From: Gerard Tuckerman <Gerard.Tuckerman@MidCoast.nsw.gov.au>
Sent: Wednesday, 15 August 2018 6:44 PM
To: 'bob@tatland.com.au'; Bruce Moore
Cc: Ledum Yorgure
Subject: RE: Riverside - Channels

Thanks for the time today to discuss and resolve the outstanding issue associated with the existing Myall Quays water quality basin 8c and the southern floodway within the modified Riverside Concept layout. I commend you and Adrian on the professional approach taken by providing analysis based on checking and running the flood models to determine velocities, water levels and storm events which would drive flows within the south branch floodway. The evidence based approach provides confidence to Council that the existing water quality treatment provided by basin 8C for several lots in Leeward Circuit can be suitably modified to ensure that there is no net change in treatment of the existing stormwater discharge as part of the final design of the south branch floodway. The commitment to undertake replacement action of the basin function within Stage 1 and the design work in the first overall DA for the development is satisfactory.

RE: HYDROLOGICAL COMMENTS IN RESPONSE TO COUNCIL'S LETTER OF 19

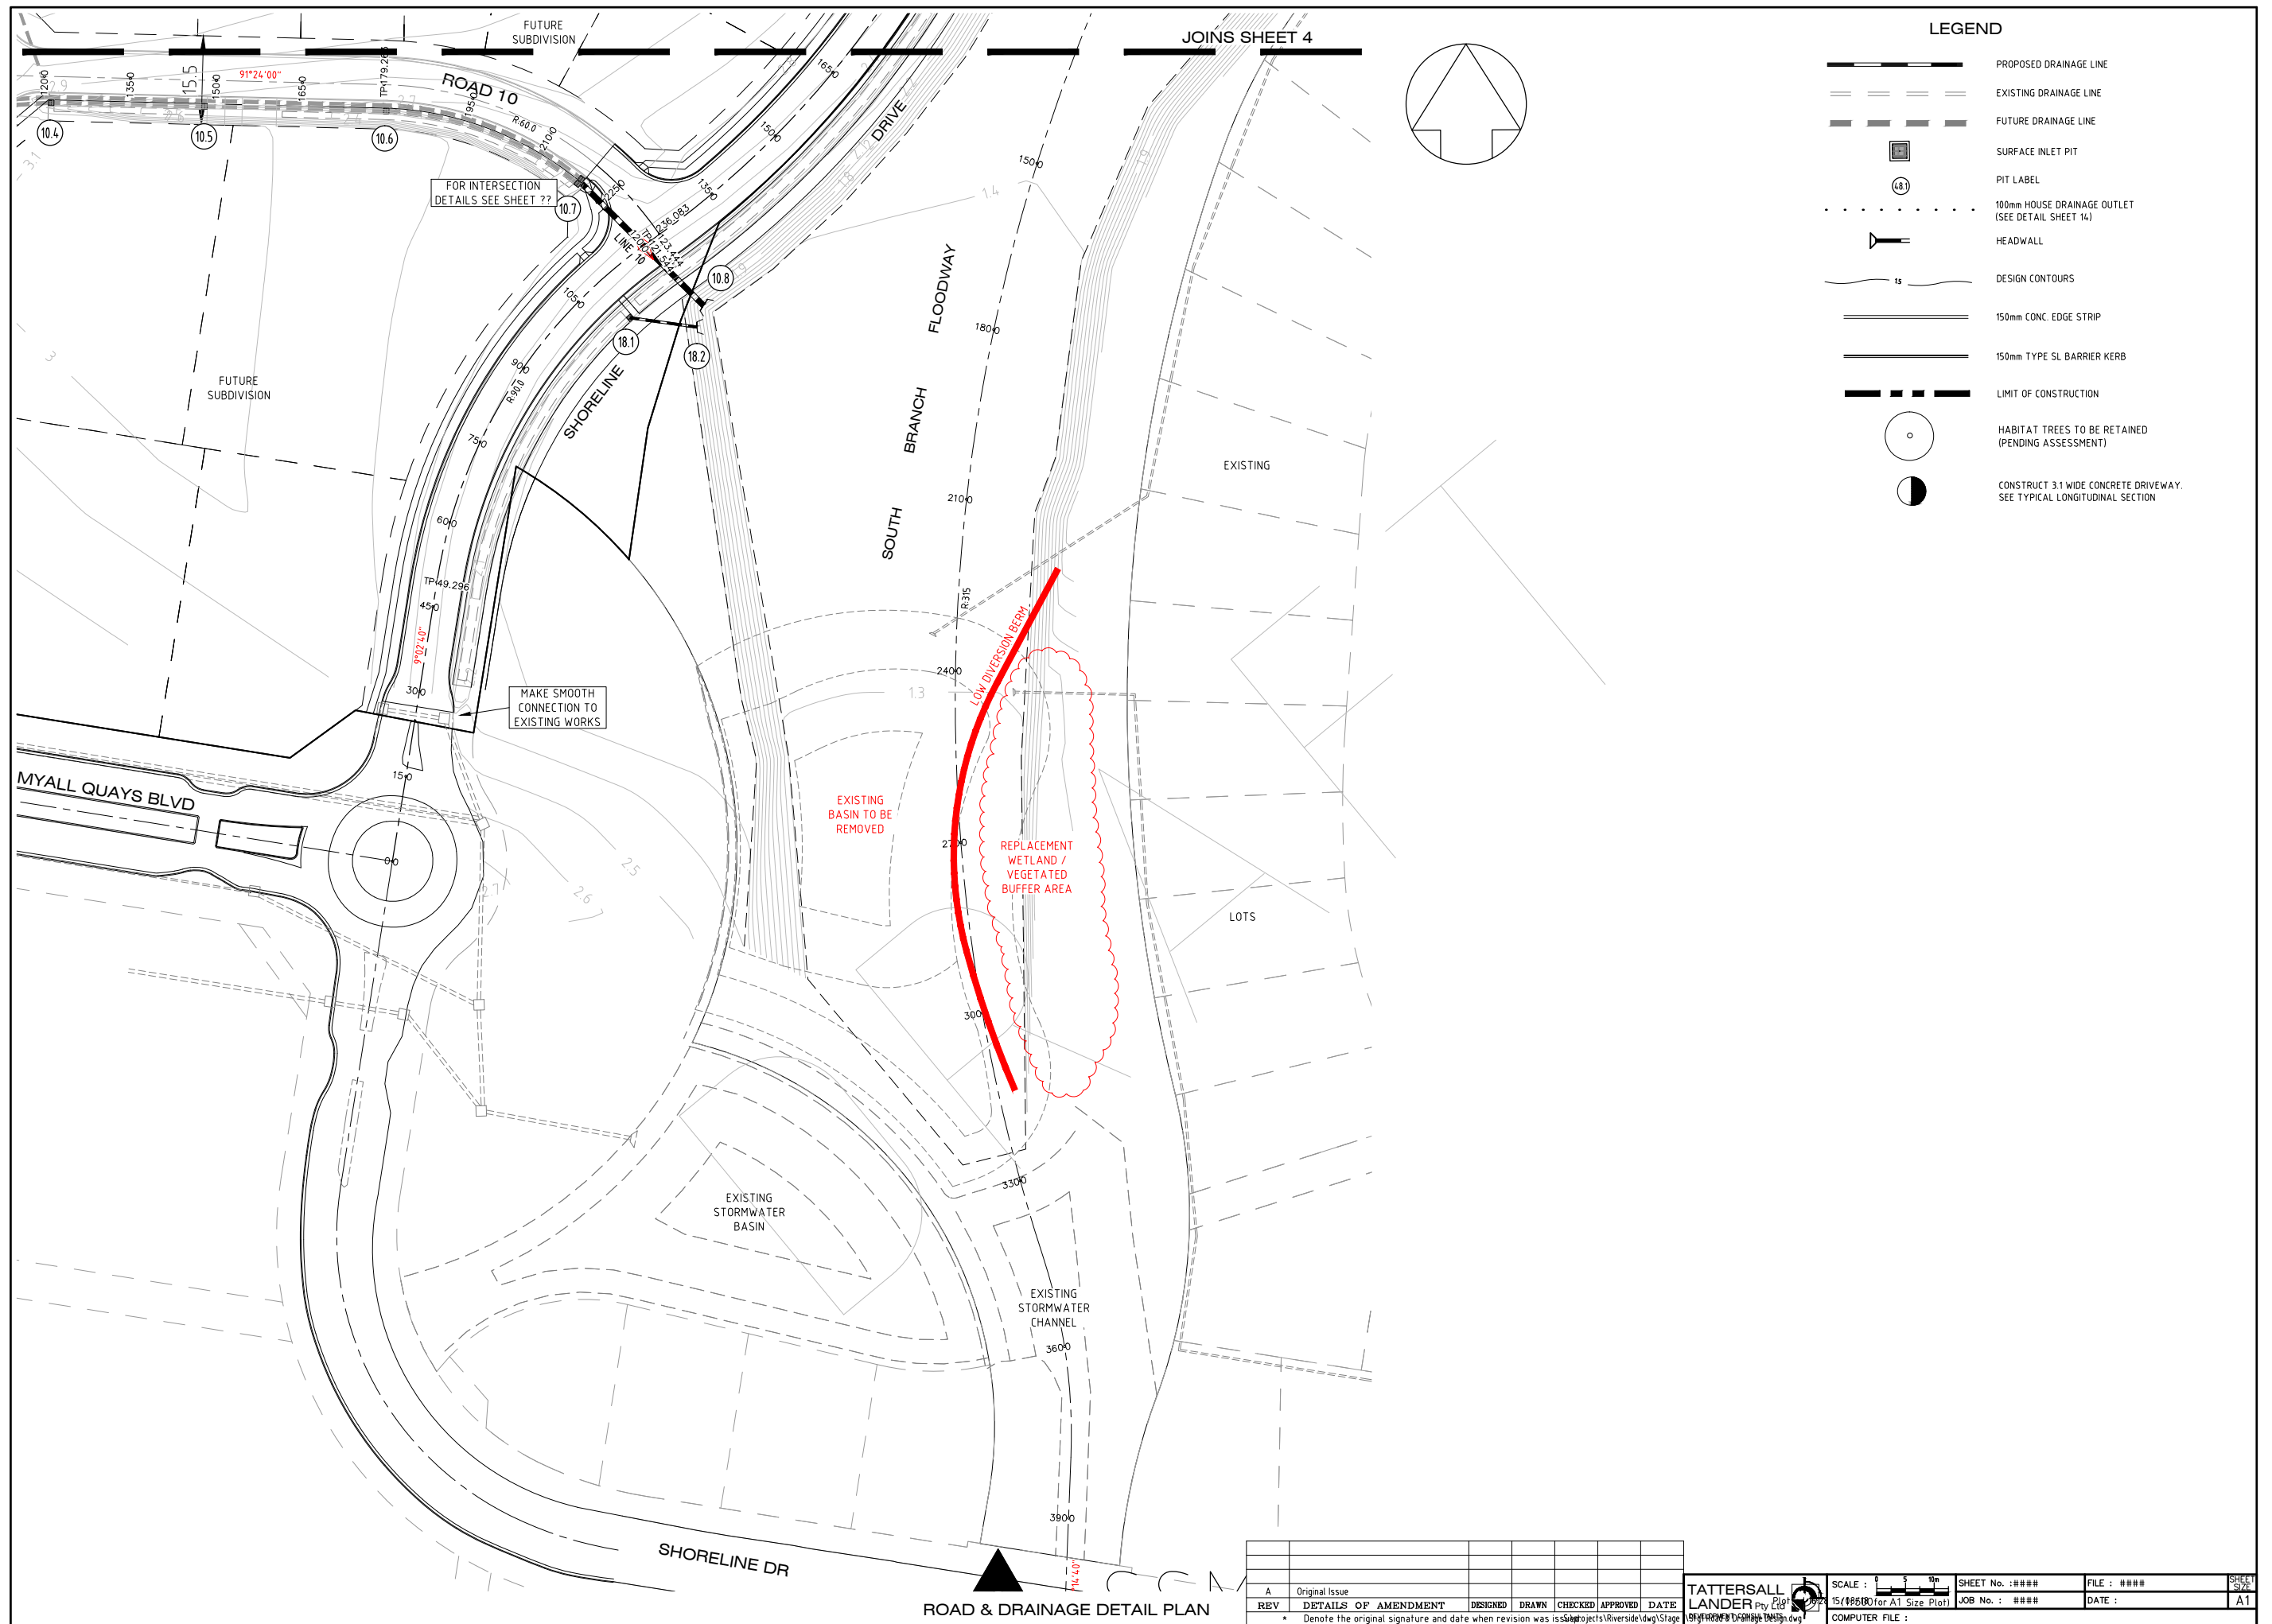
1. The attached plan indicates our initial thoughts on the replacement of this basin and as discussed this replacement action can be undertaken with the initial Stage 1 construction activities.
2. The design work for this replacement arrangement will be incorporated into the first overall DA for the development.

As such, the basin is actually only providing treatment for 5 lots. As discussed, there is no depth available between the outlet level and the groundwater to install biofiltration measures. However, given the generous width of this corridor I expect it will be relatively easy to build a small berm to divert quarterly event upstream flows around a new replacement WSUD device to service these four lots. This WSUD device could take the form of a lined wetland (below mean groundwater level), or vegetated buffer strip/wide swale (if groundwater interference is not preferred/allowed) – see attached PDF.
